## IMPORTANT SAFETY RECALL NHTSA Recall# 22V-758

This notice applies to certain trailers equipped with Waltco WDV-35 Dual Ramp lift gate

# CONSPICUITY INSTALL DOLLAR GENERAL DUAL RAMP - WDV

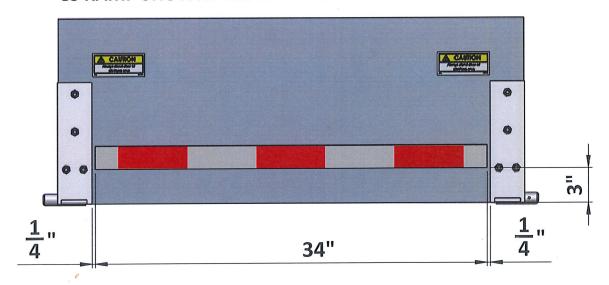
Waltco Dual Ramp lift gates installed on the back of certain Wabash trailers have obscured the Wabash-installed rear conspicuity tape placed at deck height per FMVSS 108.

The rear deck height is not identified as required in S8.2.3 of FMVSS 108; limited visibility of the rear of a trailer to nearby drivers could increase the risk of a crash.

- 1. THOROUGHLY CLEAN THE RAMP SURFACE WITH A CLEANING AGENT AND DEGREASER IF NECESSARY.
- 2. CUT TAPE SYMMETRICALLY AND TO LENGTH AS SHOWN BELOW.
- 3. PEEL OFF THE BACKING, AND ADHERE TAPE TO THE RAMP AS IN THE DIAGRAM BELOW.
- 4. RUB ACROSS THE ENTIRE TAPE STRIP SURFACE TO ENSURE PROPER ADHESION.

### CS RAMP SHOWN. REPEAT PROCEDURE FOR DS RAMP
